SUBJECT: SYSTEMATIC EVALUATION PROGRAM (SEP) FOR THE LACROSSE
BOILING WATER REACTOR - EVALUATION REPORT ON TOPICS
VI-2.D AND VI-3

SAFETY EVALUATION REPORT
ON
CONTAINMENT PRESSURE AND
HEAT REMOVAL CAPABILITY
SEP TOPIC VI-3
AND
MASS AND ENERGY RELEASE
FOR POSSIBLE PIPE BREAK
INSIDE CONTAINMENT,
SEP TOPIC VI-2.D
FOR THE
LACROSSE NUCLEAR POWER PLANT

SEP Containment Analysis and Evaluation
for the La Crosse Nuclear Power Plant

FIGURE 3

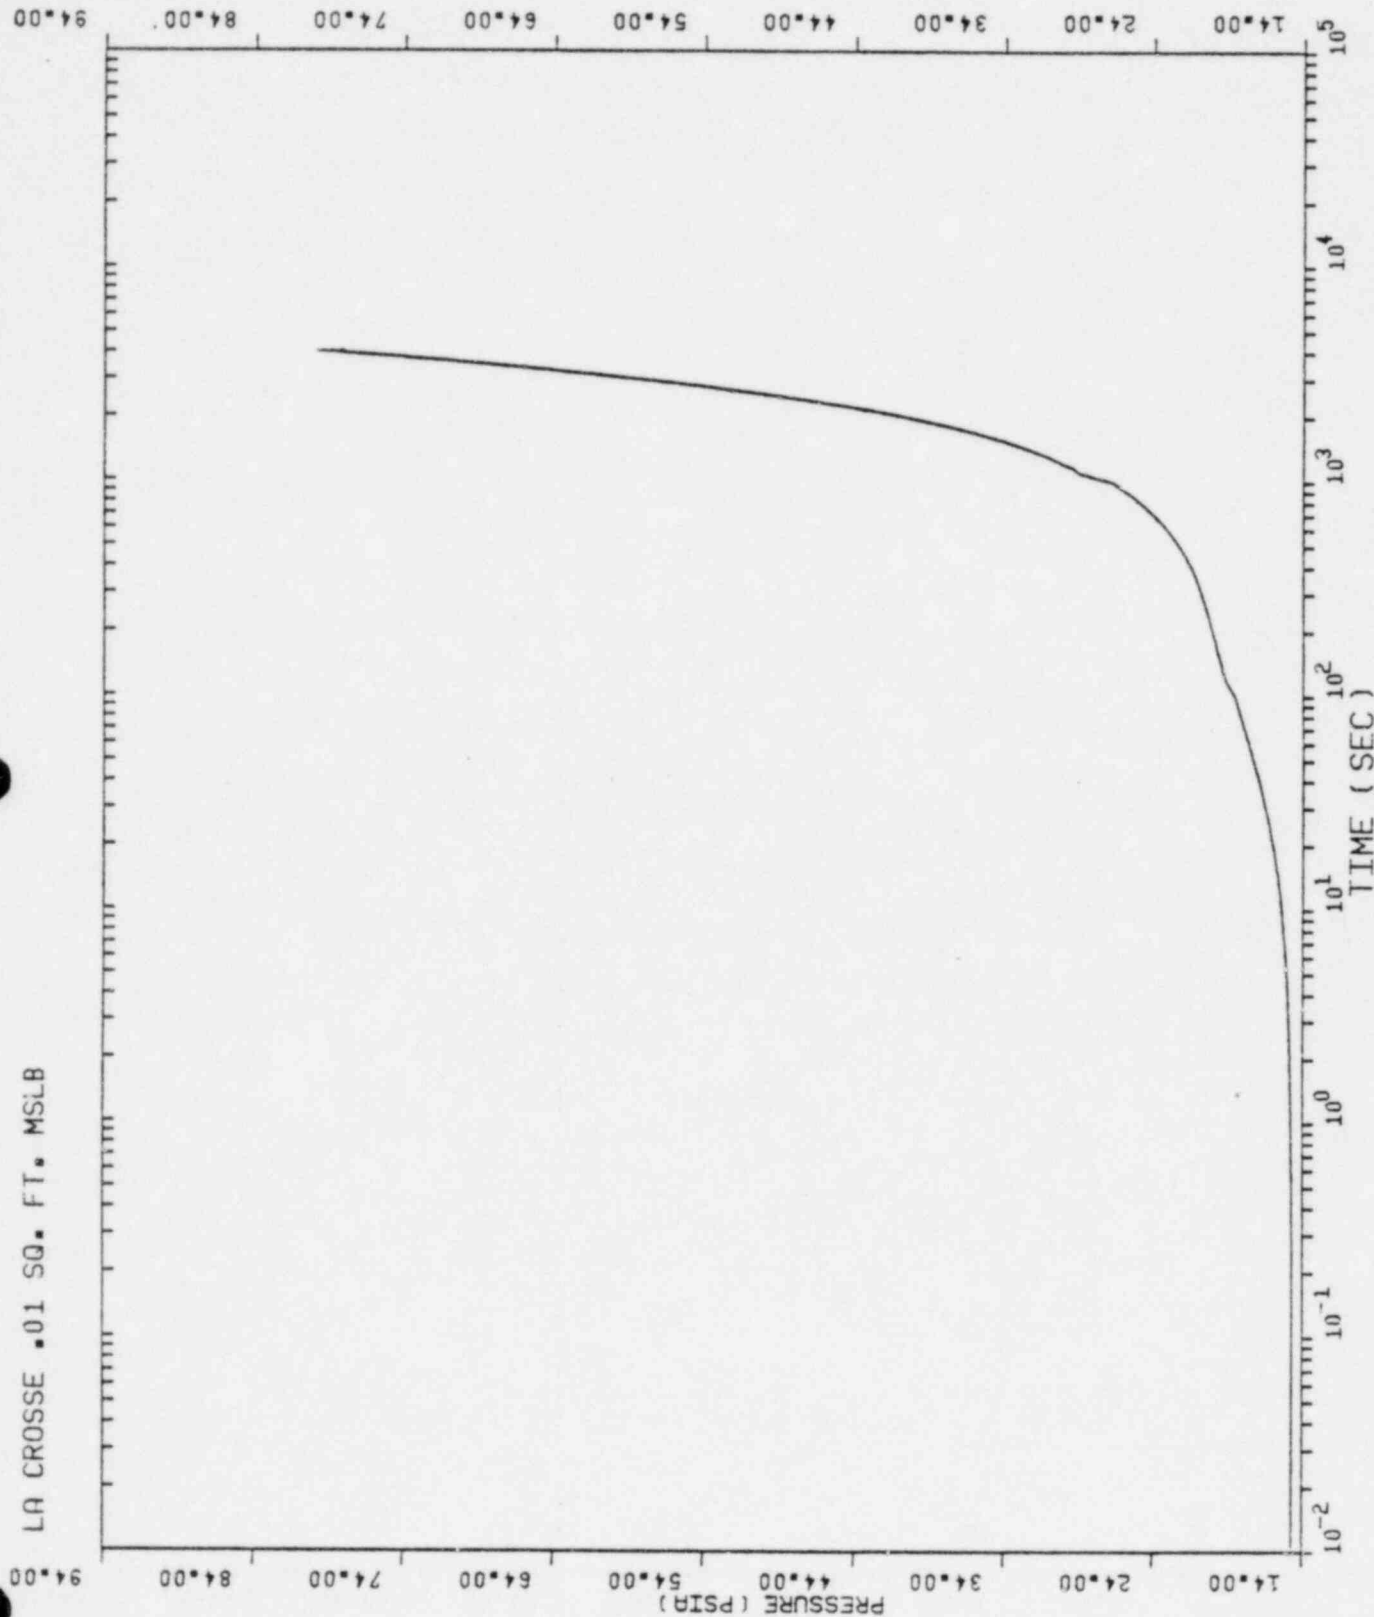
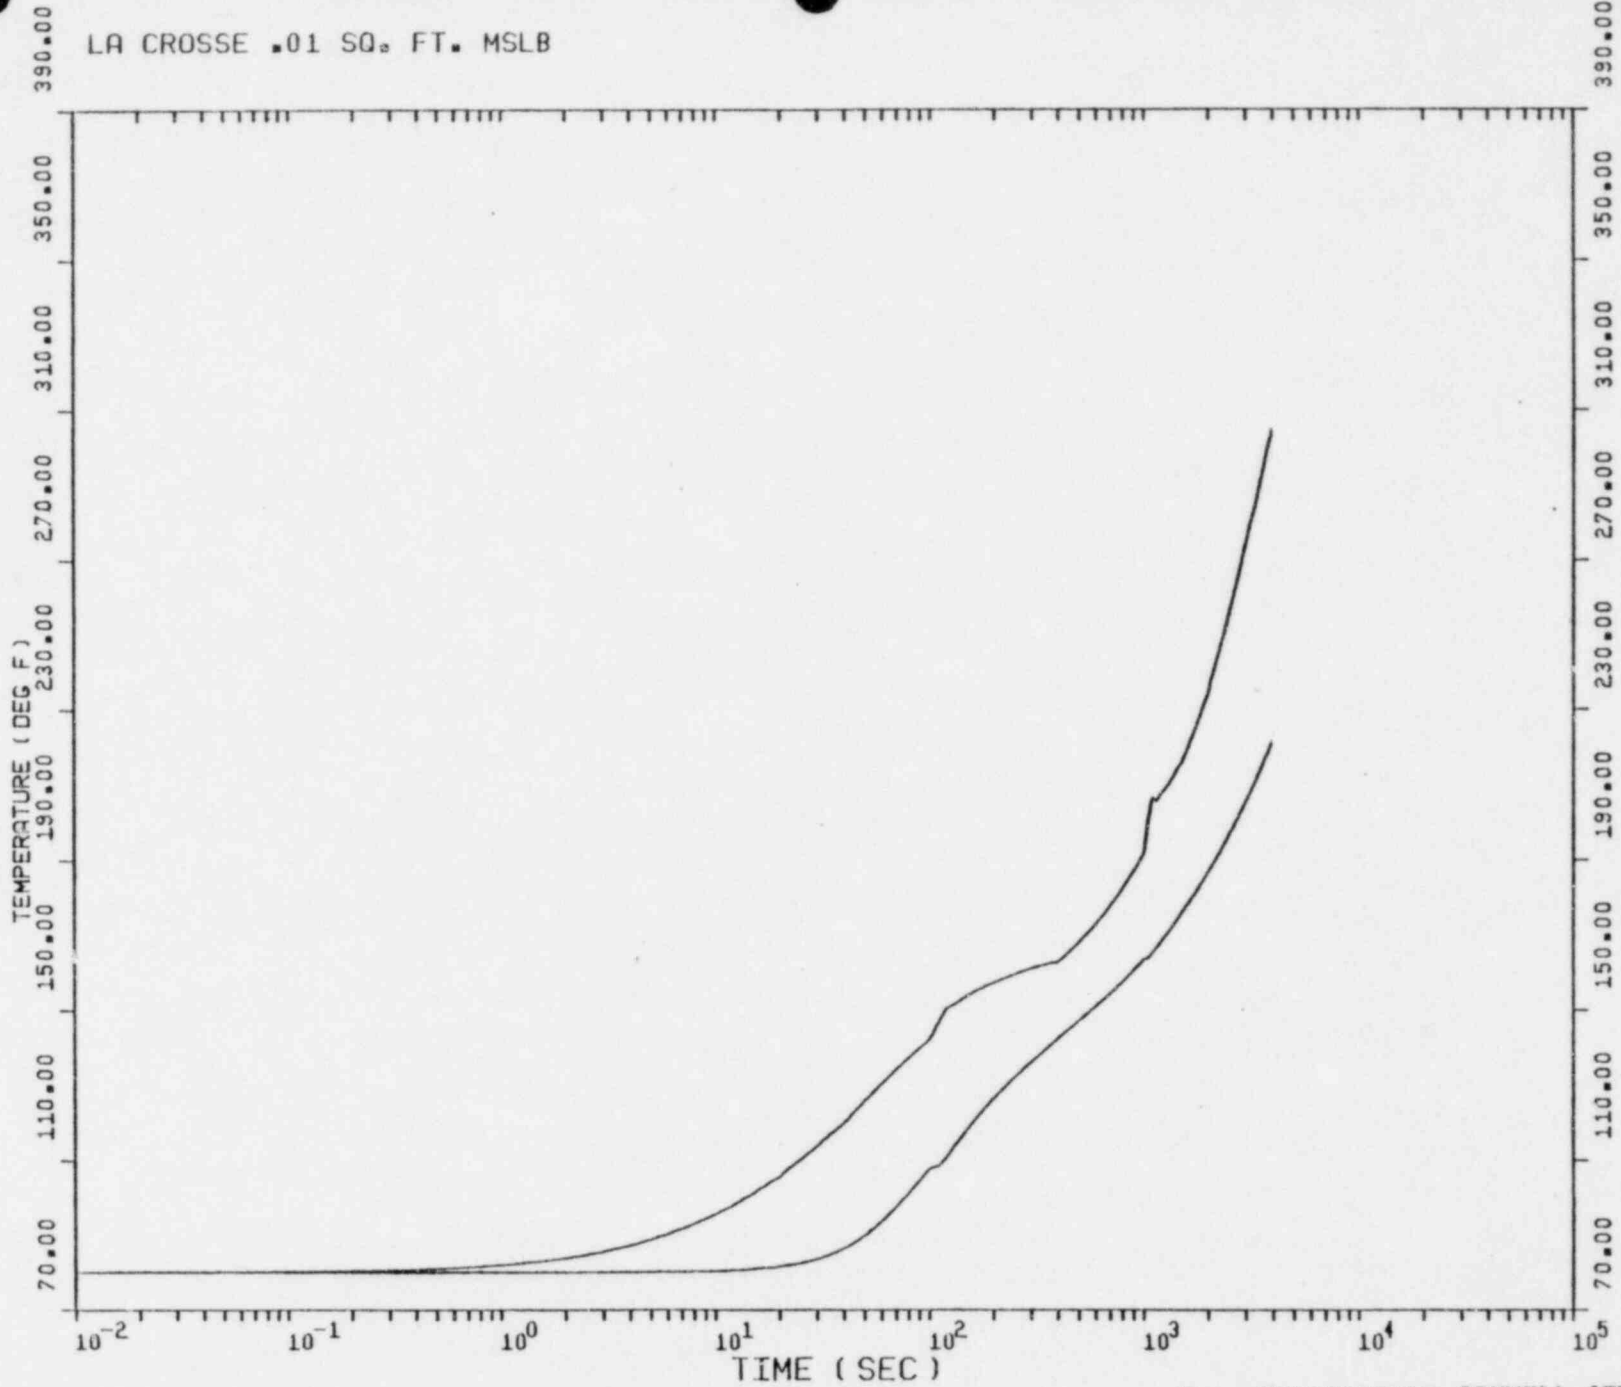
Figures 3 and 4 show the containment pressure and temperature responses, respectively, for the 0.01 ft² break. These curves serve as an upper bound since the blowdown was held constant from 200 seconds to 4000 seconds. Inspection of these curves indicates that the design pressure of 52 psig and temperature of 280°F would be reached in 56 minutes and 53 minutes, respectively. This is the amount of time that exists for the reactor operator to take appropriate action such as to manually actuate the containment sprays or the Automatic Depressurization System (ADS). These actions having been taken and become effective by 53 minutes will insure that the containment will not exceed its design pressure and temperature limits. The staff believes that the LaCrosse plant reactor operators would be able to respond within this time frame to take action which would terminate the transient and limit the containment response to within allowable design values.

Figure 5. Containment Pressure Response to a 0.10 sq. ft. Main Steam Line Break

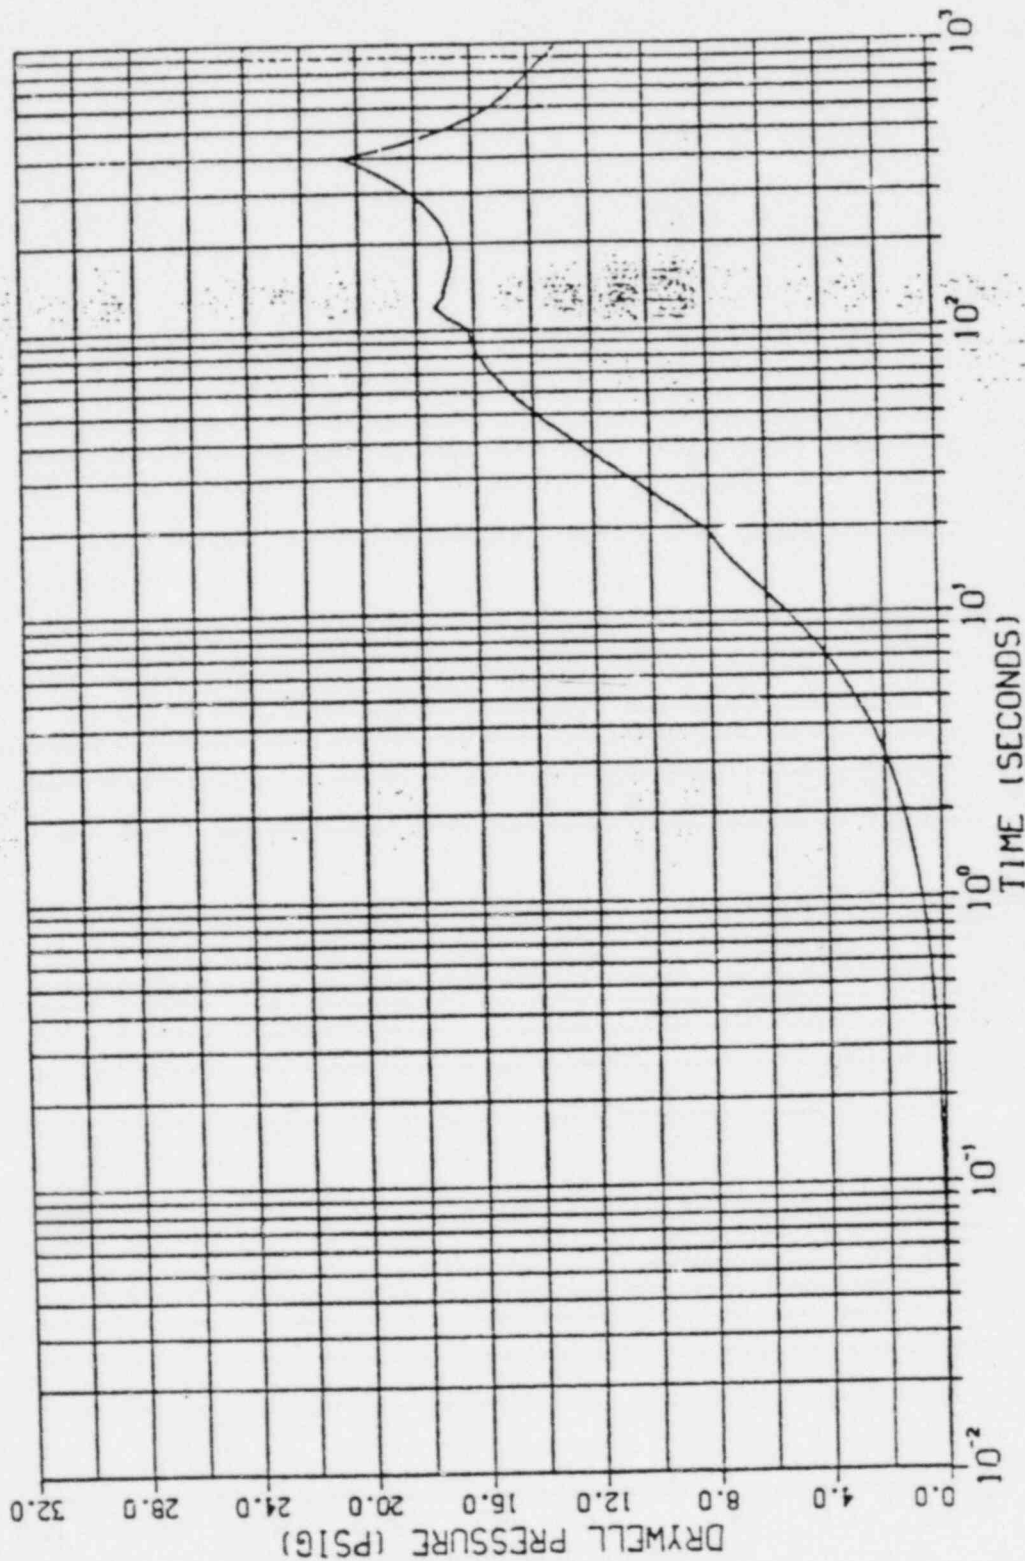
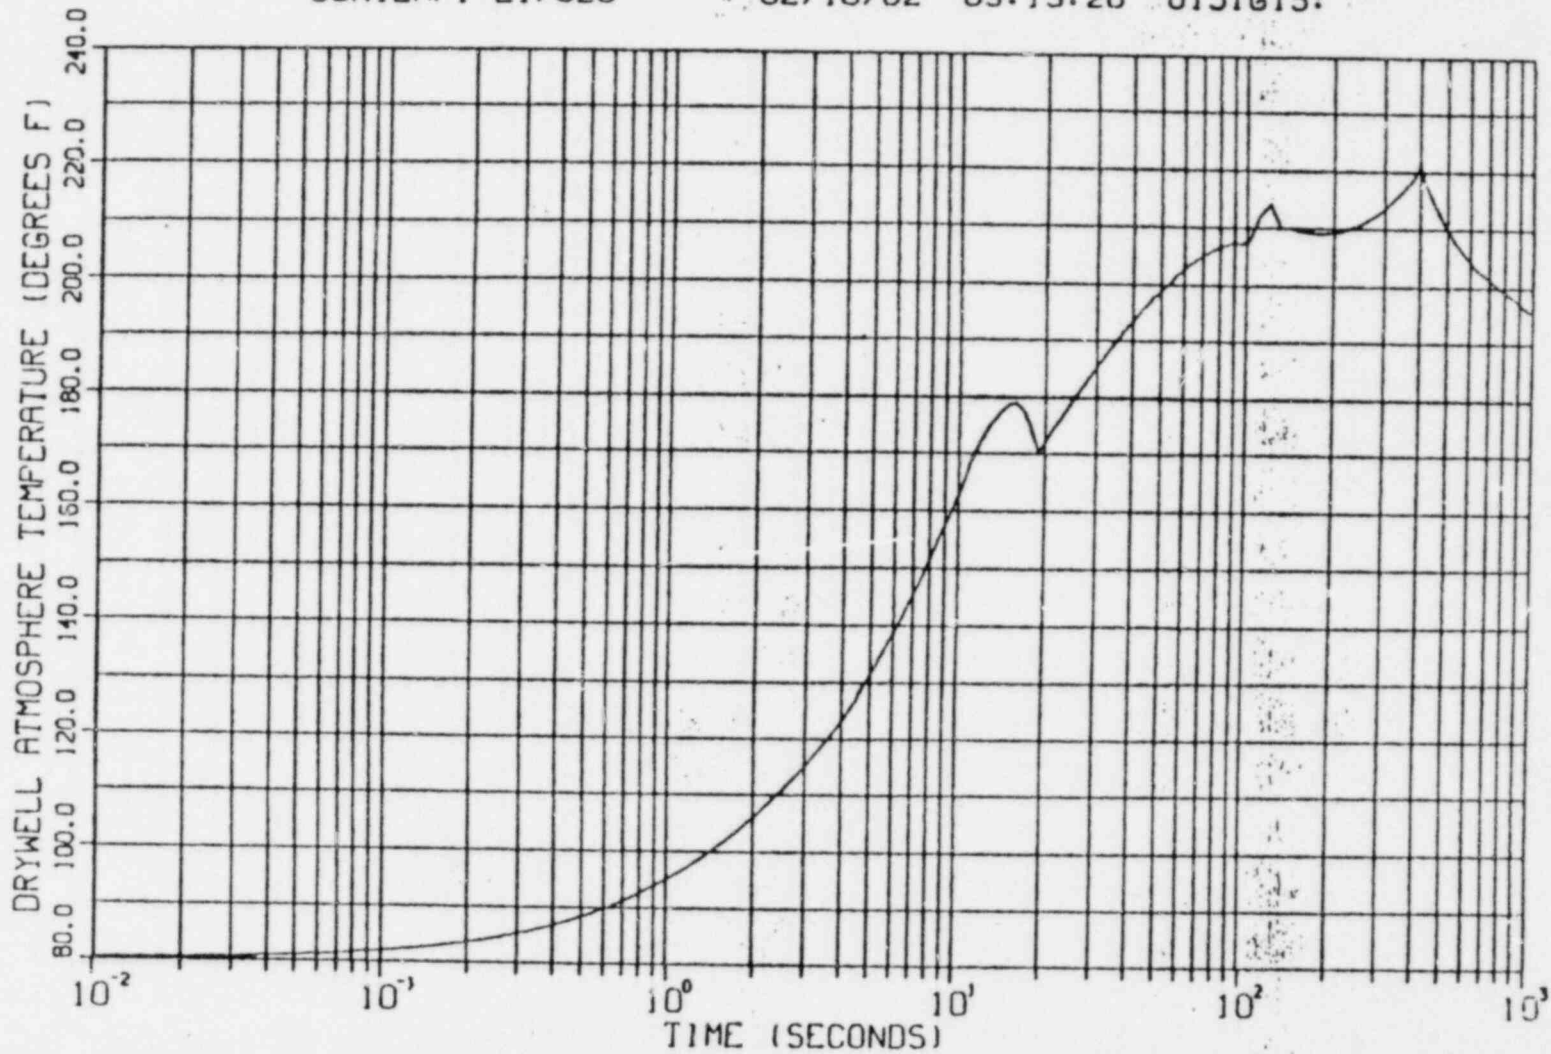
The response to a 0.1 ft² steam line break are shown in Figures 5 and 6. The calculated transient in this case reflects a peak post accident containment pressure of 21 psig and a temperature of 220°F. The response to the 0.634 ft² break is shown in Figures 7 and 8. This represents a double ended break of the eight inch steam line. The calculated transient reflects a peak post accident pressure of 33 psig and a temperature of 250°F. Neither the 0.10 ft² nor the 0.634 ft² break require operator action due to the fact that these larger break sizes cause the primary system to depressurize in a much faster time frame than the smaller 0.01 ft² break.
